**Carson Unit Coal 18 Com 1**

**DJR Operating, LLC requests permission to plug & abandon the subject well per the attached procedure, current and proposed wellbore diagram.**

### Carson Unit Coal 18 COM 1

CONDITIONS OF APPROVAL

## Proposed P&A

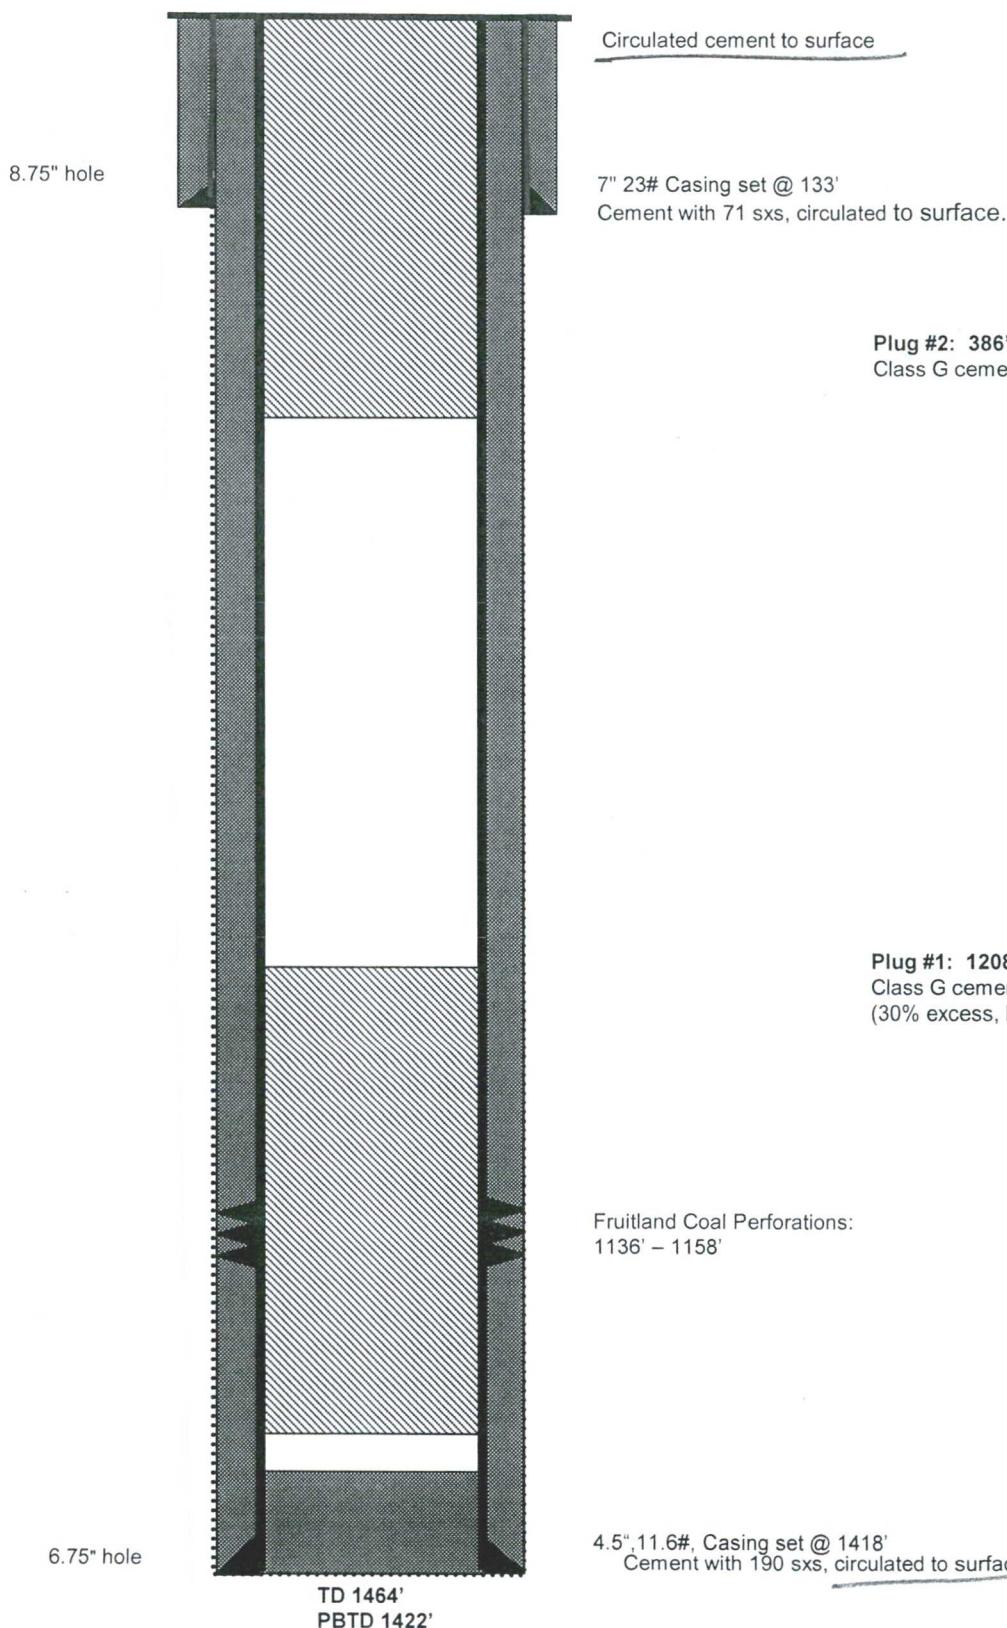
1. Plugging operations authorized are subject to the attached "General Requirements for Permanent Abandonment of Wells on Federal and Indian Lease."
2. Farmington Office is to be notified at least 24 hours before the plugging operations commence (505) 564-7750.
3. The following modifications to your plugging program are to be made:
  - a) Set Plug #1 **(1208 – 830) ft.** to cover the Fruitland top. **BLM picks top of Fruitland at 880 ft.**
  - b) Set plug #2 **(391 – 0) ft.** to cover the surface casing shoe and the Kirtland and Ojo Alamo tops. **BLM picks top of Kirtland at 341 ft.**

You are also required to place cement excesses per 4.2 and 4.4 of the attached General Requirements.

## Proposed P&A

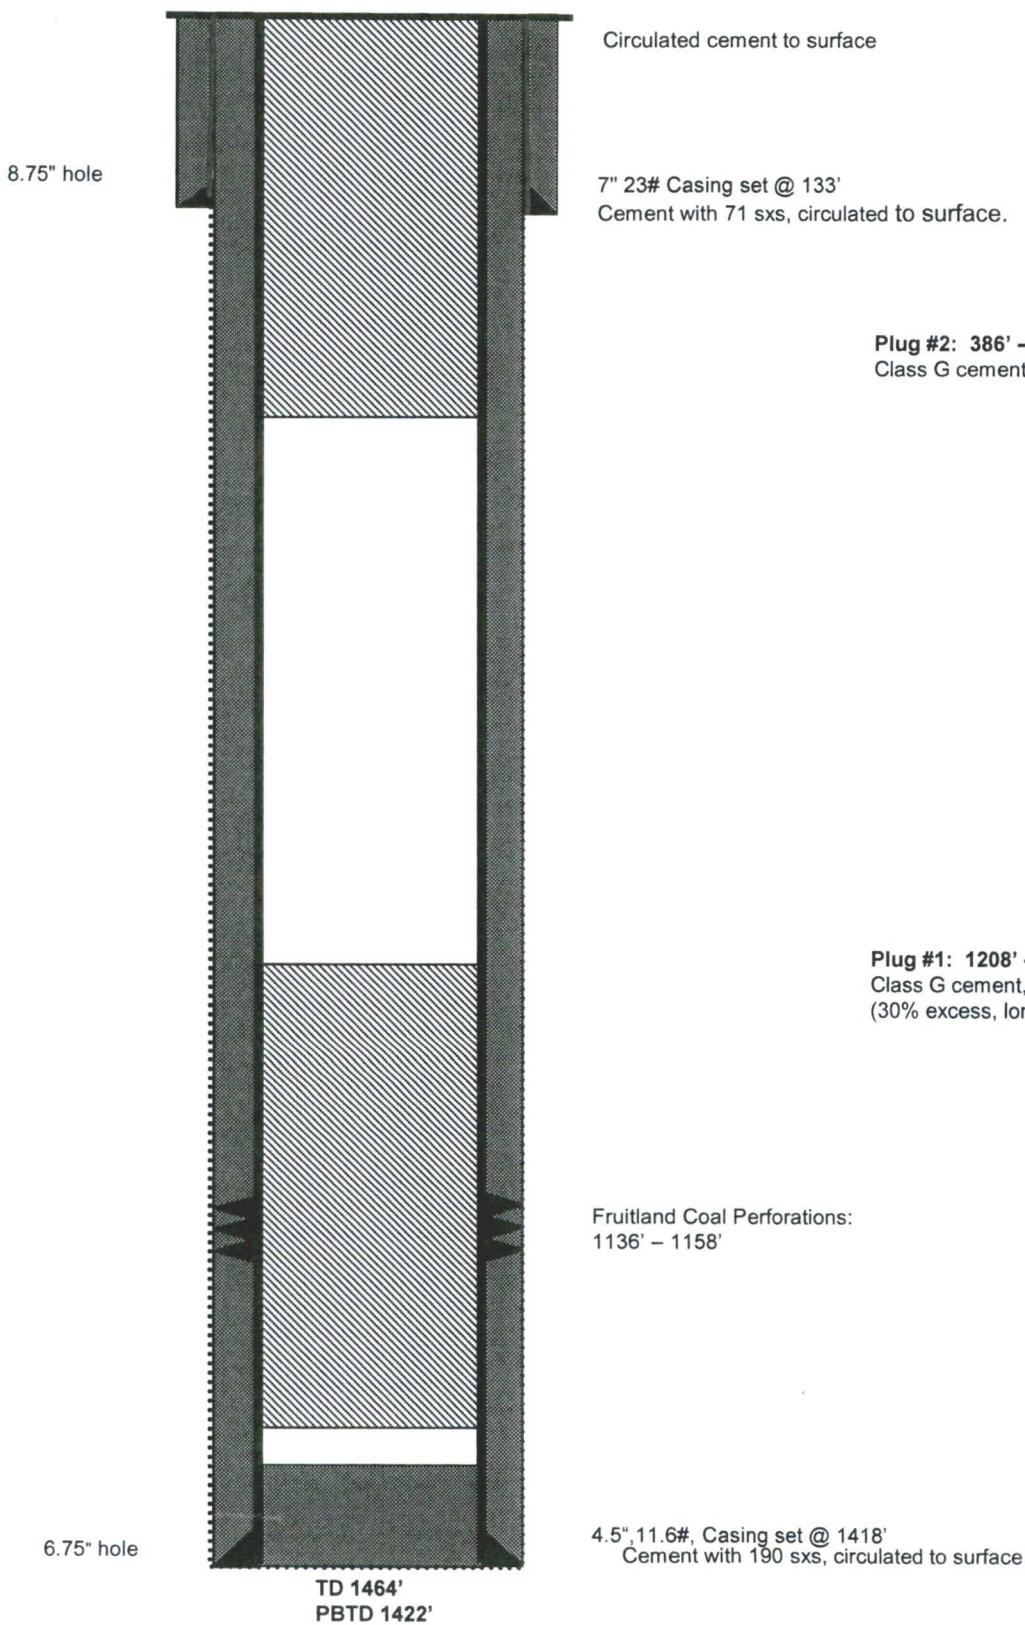
1. Plugging operations authorized are subject to the attached "General Requirements for Permanent Abandonment of Wells on Federal and Indian Lease."
2. Farmington Office is to be notified at least 24 hours before the plugging operations commence (505) 564-7750.
3. The following modifications to your plugging program are to be made:
  - a) Set Plug #1 (1208 – 830) ft. to cover the Fruitland top. **BLM picks top of Fruitland at 880 ft.**
  - b) Set plug #2 (391 – 0) ft. to cover the surface casing shoe and the Kirtland and Ojo Alamo tops. **BLM picks top of Kirtland at 341 ft.**

You are also required to place cement excesses per 4.2 and 4.4 of the attached General Requirements.
